# UNITED STATES PATENT AND TRADEMARK OFFICE

APPLICATION NO.	FILING DATE	FIRST NAMED INVENTOR	ATTORNEY DOCKET NO.	CONFIRMATION NO.
10/099,645	03/14/2002	Aurelio J. Gutierrez	PENG.617A	2221
27299	7590	11/20/2003	EXAMINER	
GAZDZINSKI & ASSOCIATES 11440 WEST BERNARDO COURT, SUITE 375 SAN DIEGO, CA 92127			TSUKERMAN, LARISA Z	
			ART UNIT	PAPER NUMBER
			2833

# Office Action Summary

### **DETAILED ACTION**

## Attachment 1

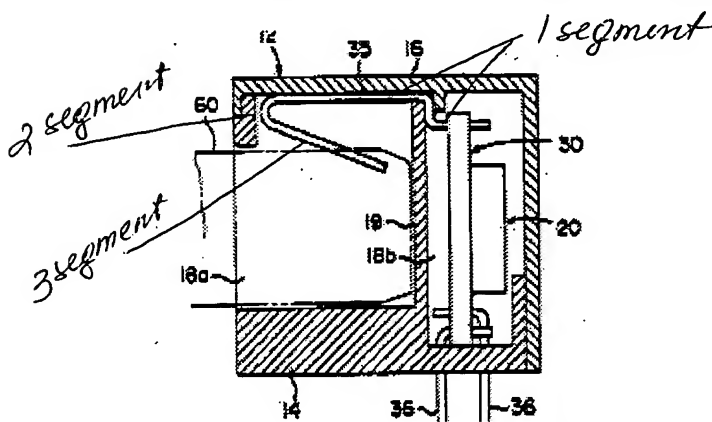
**In regard to claim 5**, Sakamoto et al. disclose the first conductors 35 comprise at least three conductor segments (see Examiner's Attachment 1), the at least three segments comprising:

- (i) at least a first segment oriented **substantially** normal to the at least one substrate 30;
- (ii) at least a second segment communicating with the at least first segment, the second segment having a substantially different angular orientation with respect to the at least one substrate 30 than the at least first segment; and
- (iii) at least a third segment communicating with the at least second segment, the third segment having a substantially different angular orientation with respect to the at least one substrate than the at least first or second segments.

Attachment 2

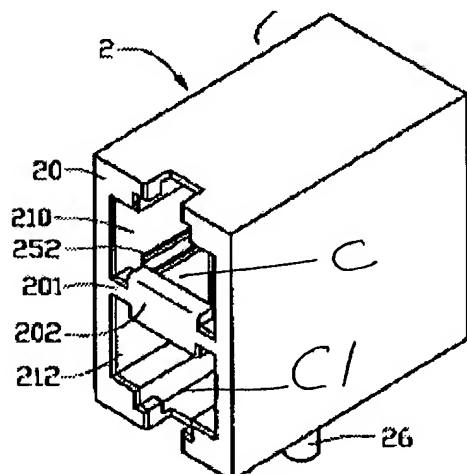
In regard to claims 1, 11, 43 and 45, Wu disclose a multi – port connector assembly (Abstract, line 1) comprising:

a connector **housing** 2 comprising a plurality of connectors C (see Examiner's Attachment 2) having:

a **recess 210** adapted for receiving at least a portion of a modular plug (not shown, Col. Line ), the modular plug having a plurality of terminals disposed thereon (not shown);

at least one **substrate (PCB) 7** having at least one electrically conductive **pathway** associated therewith;

a **cavity 22** adapted for receiving at least a portion of the at least one substrate, the at least one substrate being disposed within the cavity in substantially **orthogonal orientation** (see Fig. 1) with respect to a front face of the housing;

a plurality of **first conductors 4** disposed at least partly within the recess, the first conductor being configured to form an electrical contact with respective ones of the terminals when the modular plug is received within the recess, and for forming an electrical pathway between the first conductor and the at least one substrate 7; and

a plurality of **second conductors 61**, at least one of the second conductors being in electrical communication with the at least one electrically conductive pathway of the at least one substrate.

**In regard to claim 23**, Wu discloses at least two of the connectors C and C1 are disposed in a port pair (see Examiner's Attachment 2 and Abstract), the first conductors 4 of each connector in the port pair being substantially coplanar, the plane of the first conductors of a first connector in the port pair being substantially parallel with that of the first conductors of a second connector in the port pair.
